Technický bulletin

n. 2/08

Mercedes Sprinter 3.0 CDI Euro4 184HP mot. OM642 - A07MB119 - A07MB120

Renault - Opel - Nissan 2.5 Dci 120 Hp My 06 1RE20200E + A03130

FOTO1

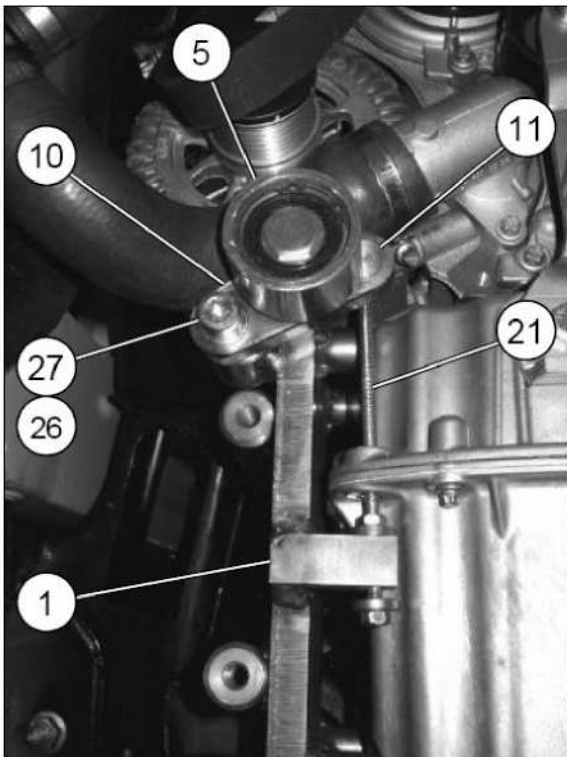
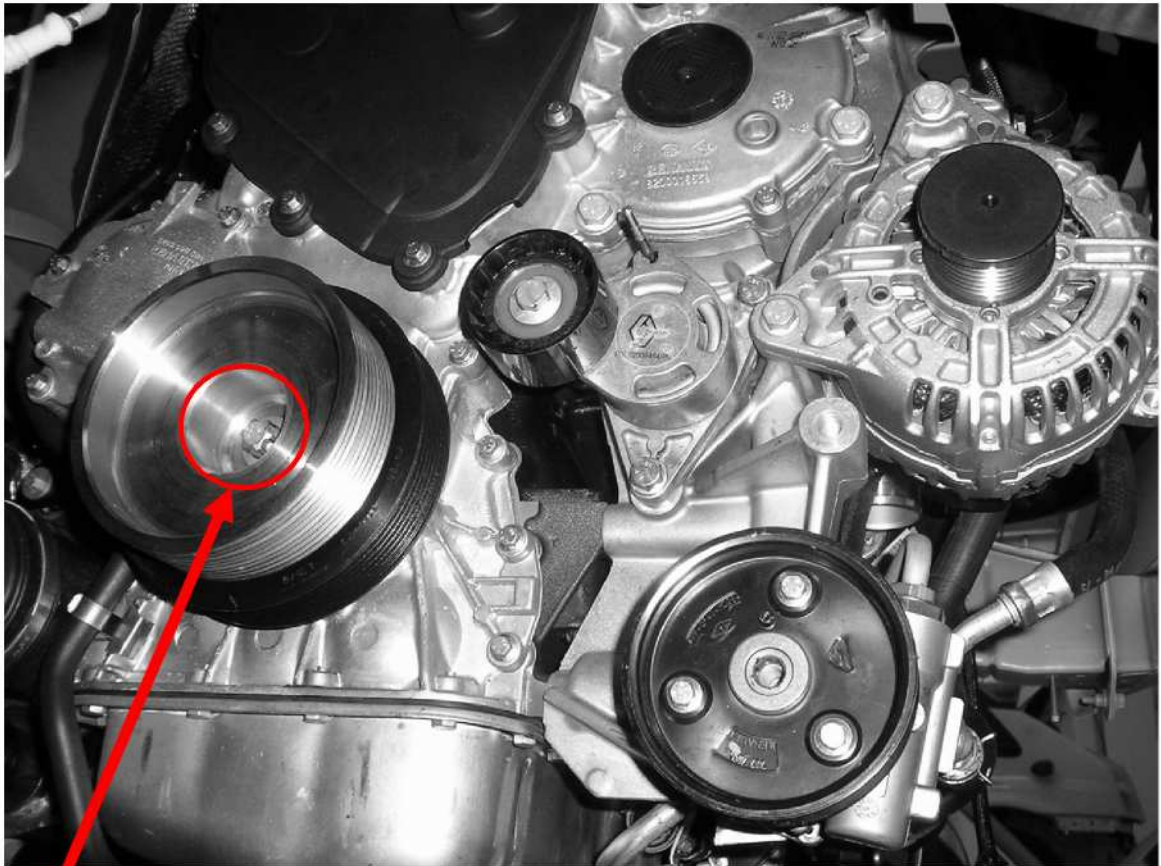
Pri montáži súprav A07MB119 (SP21) a A07MB 120 (SP21) sa môžu vyskytnúť nejaké problémy pri motore ktorý je na tretom obrázku dole. Je možná kolízia medzi nečinnou remenicou 5 a vodnou trúbkou alebo medzi skrutkou 26 a remeňom. Aby ste sa vyhli problémom, poriadne napnite remeň používajúc skrutku 21. Pre ďalšie informácie prosím kontaktujte oddelenie služieb.

The kits A07MB119 (SP15) and A07MB 120 (SP21) can create some fitting problems with engine prepared as in the 3 attached picture, due to an interference between the idle pulley 5 and the water pipe or between screw 26 and the belt. To avoid these problems, tension properly the belt using screw 21. For further details please contact the Service Department.
